Issue	Date	Event
A	04.08.22	Issue for Section 4.55

Project
28 Lockwood Avenue, Belrose

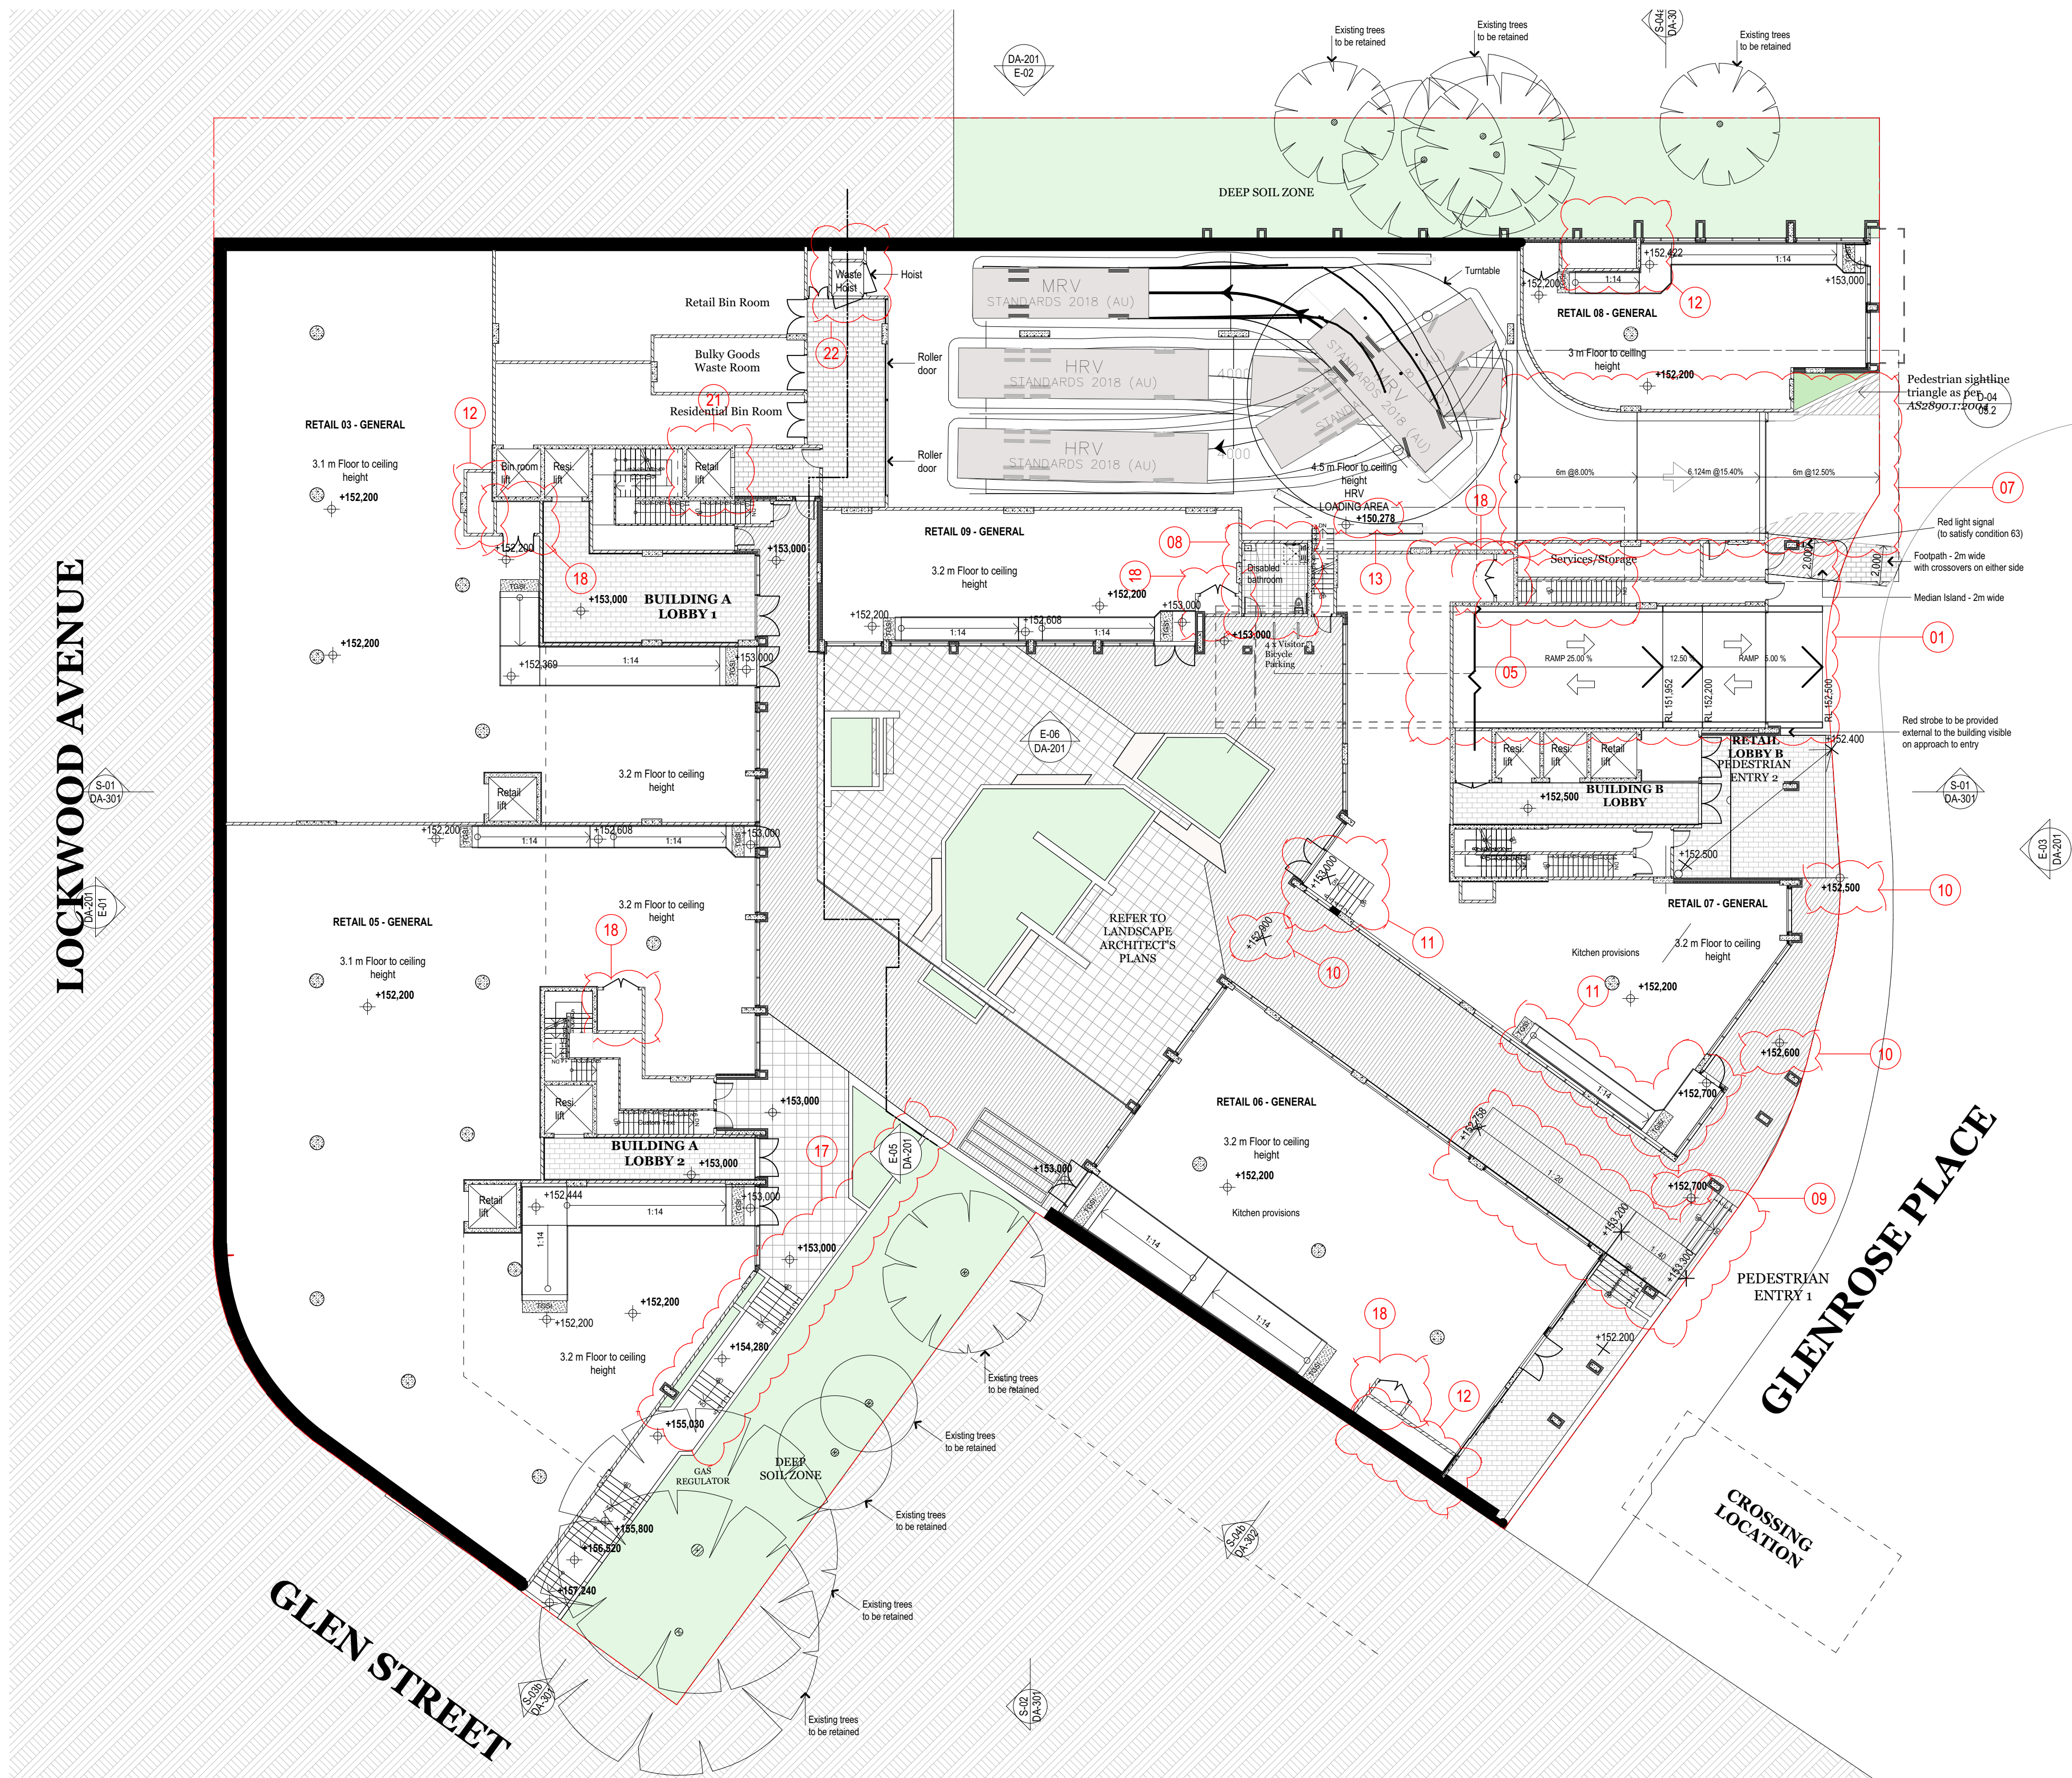
- 1- Entry and exit ramp combined and relocated.
- 2- Traffic flow, car spaces and storage cages rearranged.
- 3- Floor RL lowered.
- 4- EOT and accessible bathroom relocated.

- 5- Fire stairs relocated to comply with NCC.
- 6- Plant and utility rooms rearranged.
- 7- Loading dock entry/exit ramp modified.
- 8- Accessible bathroom provided

- 9- Glenrose pl pedestrian entry ramp and steps modified.
- 10- levels modified.
- 11- Entry to shop number 07 modified.
- 12- Mechanical exhaust shafts located.

- 13- Loading dock RL modified.
- 14- Face brick removed from intermediate exposed slab edges.
- 15- Proposed clubhouse/communal room.
- 16- Fire stairs relocated and minor internal unit rearranged adjacent to the new stair location.

- 17- Glen street pedestrian entry modified for structural rationalisation.
- 18- Electrical switch boards located.
- 19- External wall modified.
- 20- Unit 1.01: East wall relocated, balcony deleted.

- 21- Waste lift is changed to Retail lift and it drops to basement 04.
- 22- The hoist lift in the loading dock is changed to waste lift and it drops to basement 03.

- 23- Roof extended over enclosed balcony.
- 24- Internal layouts modified for more efficient, spatial use and relationship:
LG01, LG02, LG06, LG10, LG12, LG14, LG15, LG18.
G01, G02, G05, G09, G13, G15, G16.
L1.02, L1.05, L1.08, L1.12, L1.13, L1.14
The amendments for the following units are subject to section 4.55 application:
LG03, LG05, LG07, LG08, LG09, LG11, LG13, LG17, G03, G06, G08, G10, G11, G12, G14, L1.01, L1.03, L1.04, L1.09, L1.11.

- 25- New aluminum windows and doors.

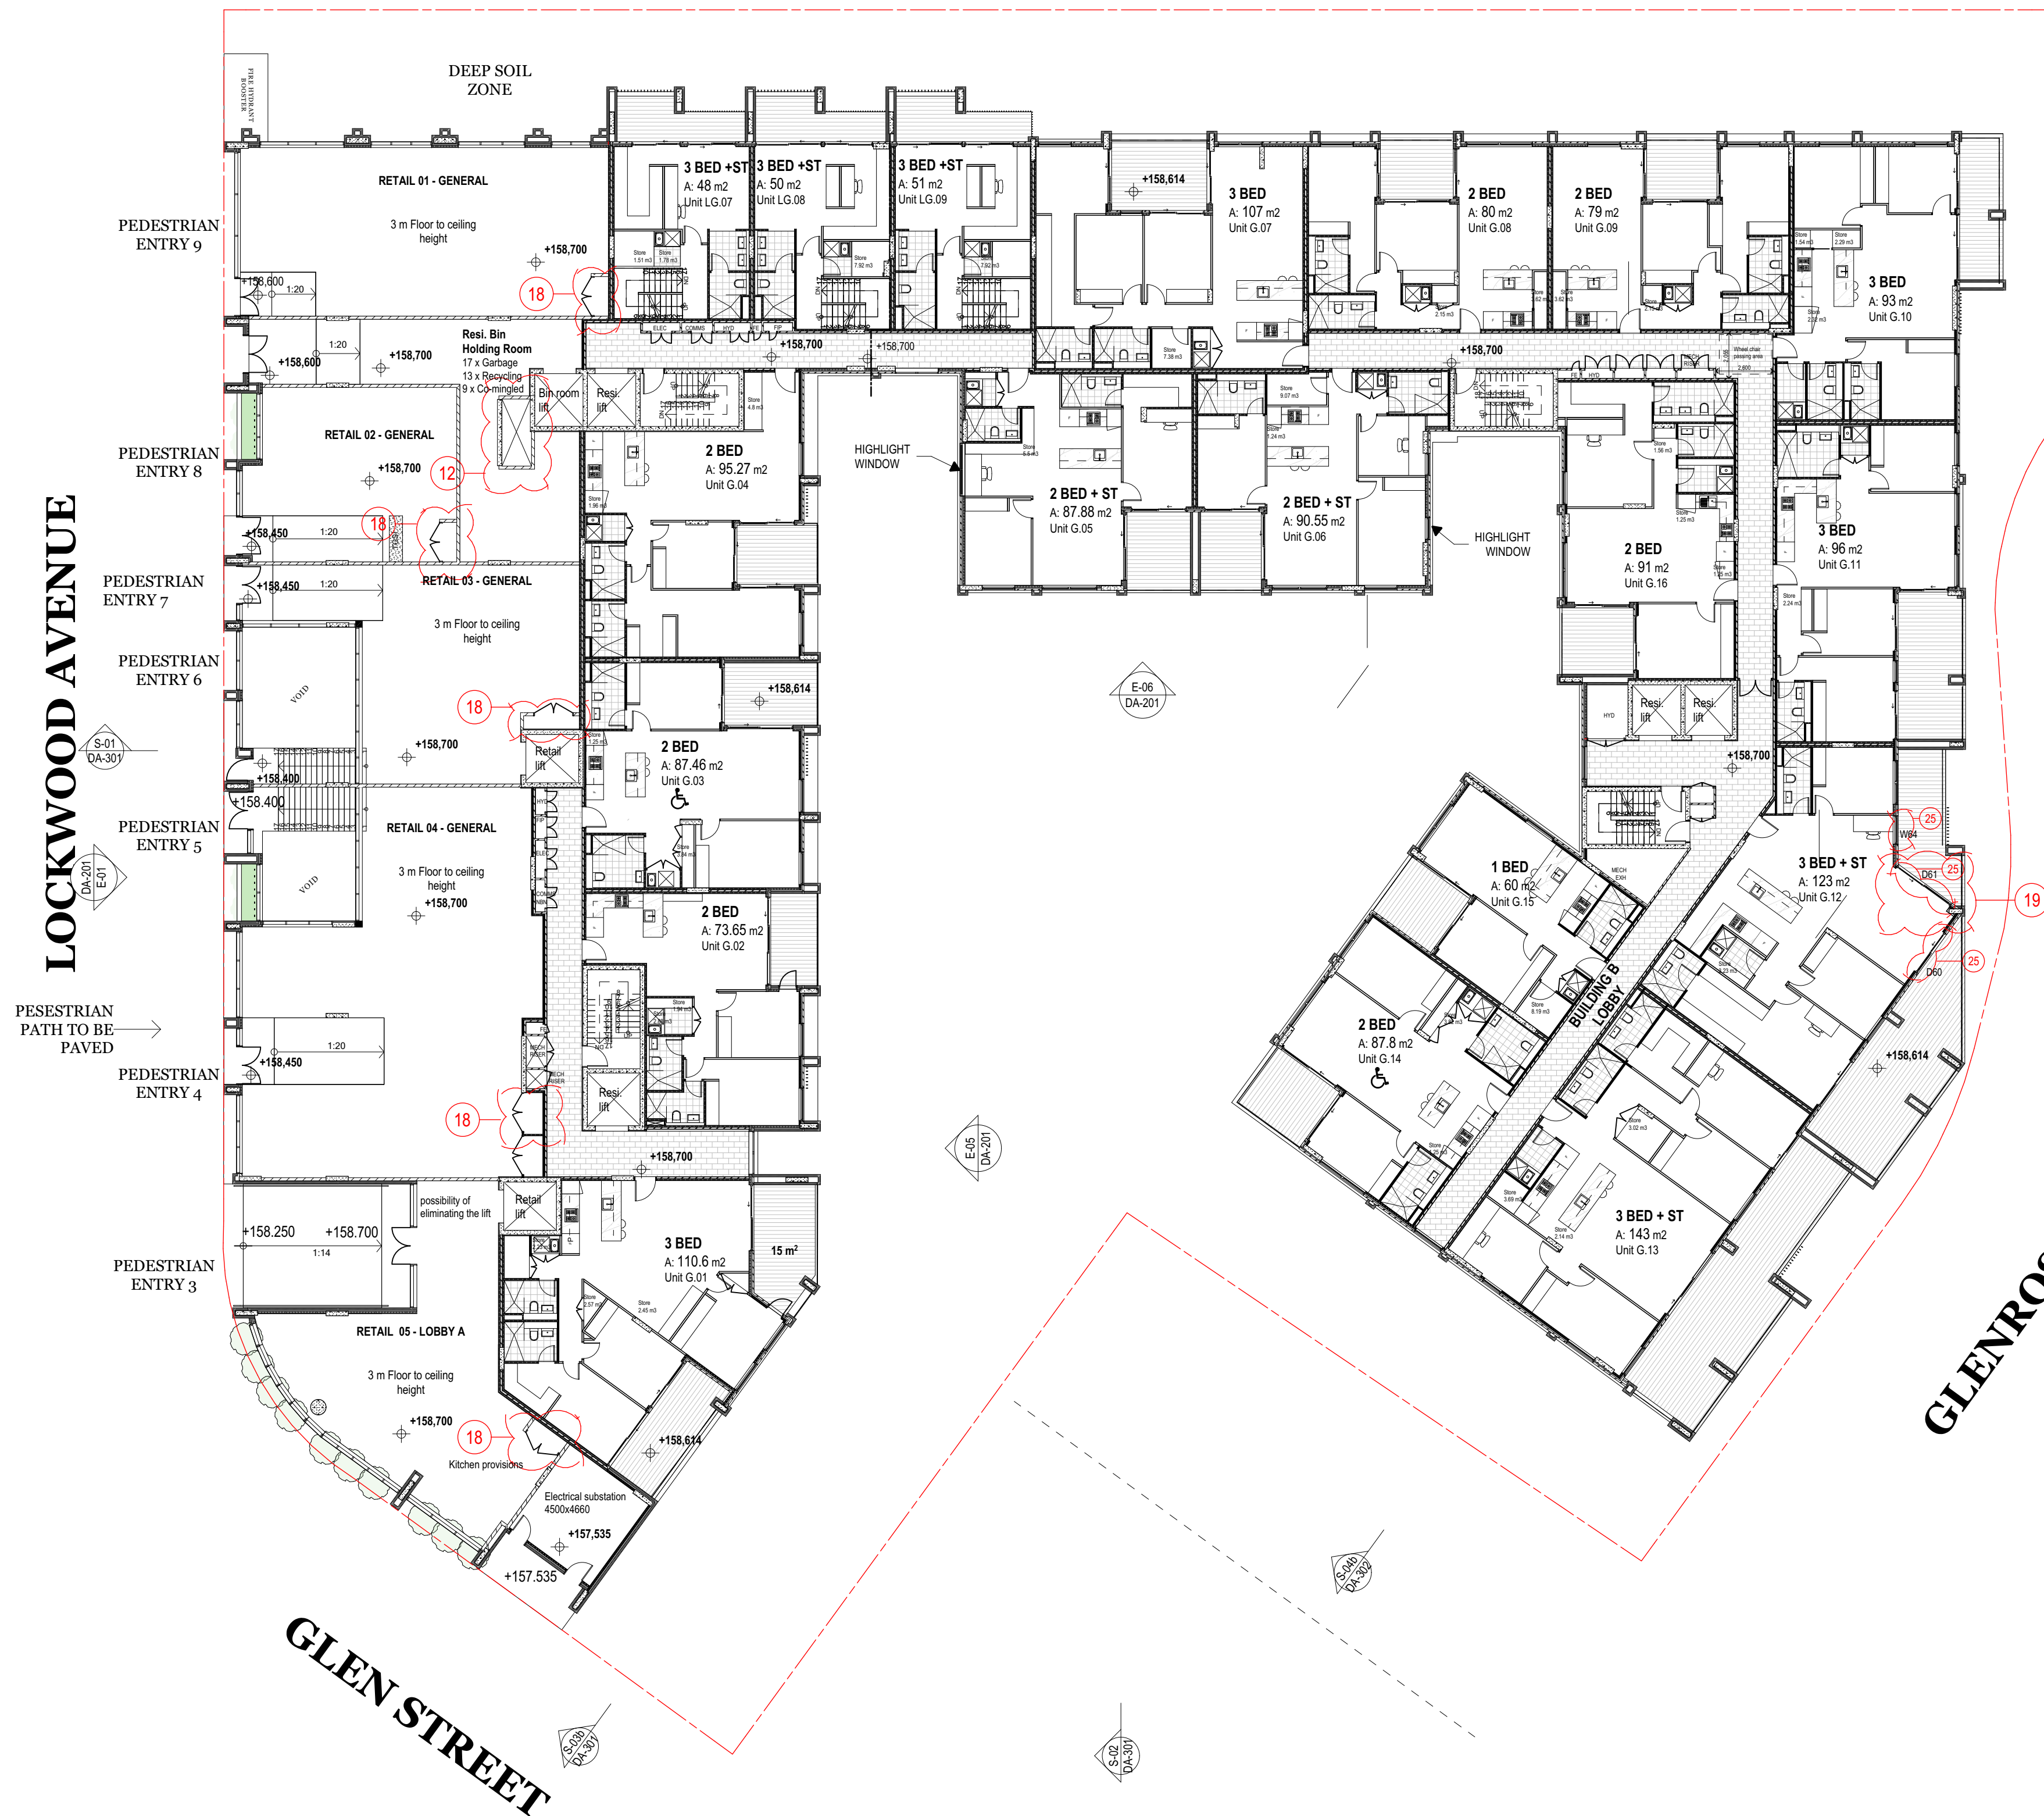
- 1- Entry and exit ramp combined and relocated.
- 2- Traffic flow, car spaces and storage cages rearranged.
- 3- Floor RL lowered.
- 4- EOT and accessible bathroom relocated.

- 5- Fire stairs relocated to comply with NCC.
- 6- Plant and utility rooms rearranged.
- 7- Loading dock entry/exit ramp modified.
- 8- Accessible bathroom provided

- 9- Glenrose pedestrian entry ramp and steps modified.
- 10- levels modified.
- 11- Entry to shop number 07 modified.
- 12- Mechanical exhaust shafts located.

- 13- Loading dock RL modified.
- 14- Face brick removed from intermediate exposed slab edges.
- 15- Proposed clubhouse/communal room.
- 16- Fire stairs relocated and minor internal unit rearranged adjacent to the new stair location.

- 17- Glen street pedestrian entry modified for structural rationalisation.
- 18- Electrical switch boards located.
- 19- External wall modified.
- 20- Unit 1.01: East wall relocated, balcony deleted.

- 21- Waste lift is changed to Retail lift and it drops to basement 04.
- 22- The hoist lift in the loading dock is changed to waste lift and it drops to basement 03.

- 23- Roof extended over enclosed balcony.
- 24- Internal layouts modified for more efficient, spatial use and relationship:
LG01, LG02, LG06, LG10, LG12, LG14, LG15, LG18.
G01, G02, G05, G09, G13, G15, G16.
L1.02, L1.05, L1.08, L1.12, L1.13, L1.14
The amendments for the following units are subject to section 4.55 application:
LG03, LG05, LG07, LG08, LG09, LG11, LG13, LG17, G03, G06, G08, G10, G11, G12, G14, L1.01, L1.03, L1.04, L1.09, L1.11.

- 25- New aluminum windows and doors.
